UNITED STATES PATENT AND TRADEMARK OFFICE

APPLICATION NO.	FILING DATE	FIRST NAMED INVENTOR	ATTORNEY DOCKET NO.	CONFIRMATION NO.
10/802,095	03/15/2004	Jong-Deog Kim	51876P592	4034
8791	7590	06/06/2005	EXAMINER	
BLAKELY SOKOLOFF TAYLOR & ZAFMAN 12400 WILSHIRE BOULEVARD SEVENTH FLOOR LOS ANGELES, CA 90025-1030			CONNOLLY, PATRICK J	
			ART UNIT	PAPER NUMBER
			2877

Office Action Summary

FIG.9

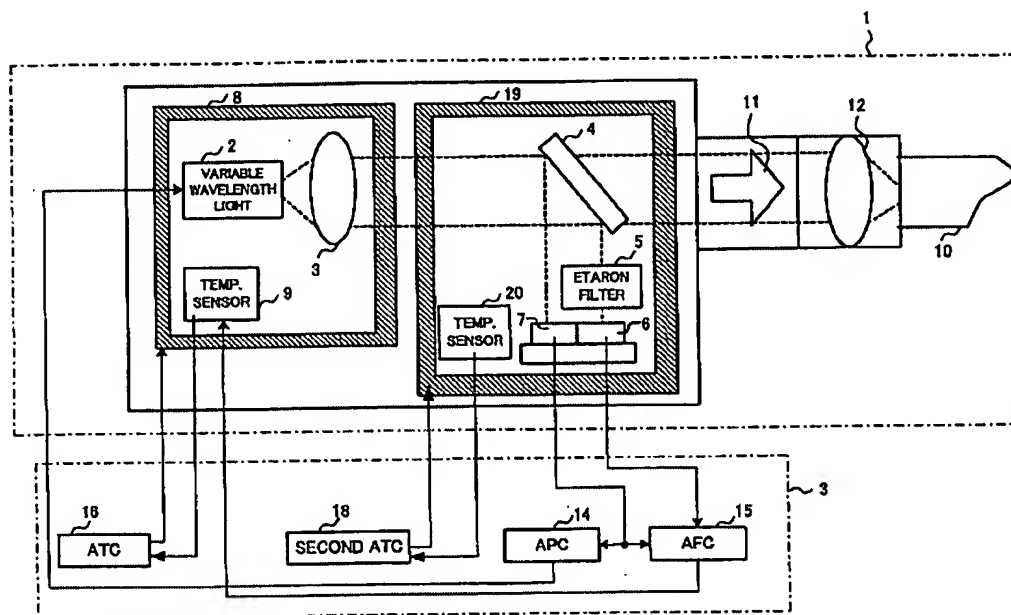
As to claim 1, Iwafuji discloses a variable wavelength light source and monitoring system including (see Figure 9 below):

a laser source control means (14) for controlling a laser source (2), wherein the light beam travels along an optical axis (11);

an optical output monitoring unit (7);
a filtering unit (5);
an optical wavelength monitoring unit (6)
a thermo-electric cooler for maintaining the temperature of the laser (16, 8);
a temperature control means for setting the etalon to a predetermined temperature (18, 19);
a comparison means for comparing the output and wavelength signals (14,15); and
a processing means for comparing signal values to present values (see Figure 11, pages 4 and 5).

As to claim 2, Iwafuji discloses monitoring the temperature of the filtering unit separately (see Figure 9, also page 5)

As to claims 3, 6, 7, 9-16, 18 and 19 Iwafuji teaches collimation means (3), separate mounting means (see Figure 9 above), a heating unit for the etalon filter (18), separate sensing temperature sensing units for the filter and laser (9 and 20).
